PCN: V16-001-F48070-MA

Product Change Notice

Issue Date: 15 Apr 2016

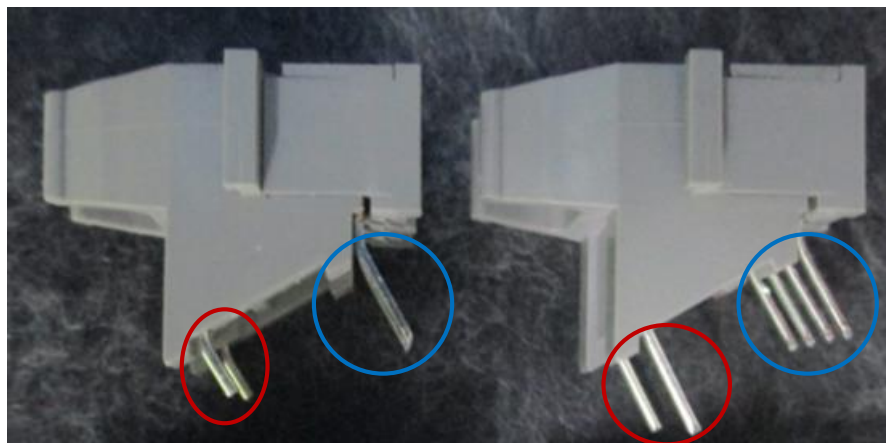
Increase the housing staple pin length from 2.8mm to 4.6mm, to be same as active pins.

Housing staple pins (pin5 and pin8 in red circle): Length increased from 2.8mm to 4.6mm.

Active pins (pin1 to pin4 in blue circle): No Change.

The base material and plating of staple pins remain unchanged.
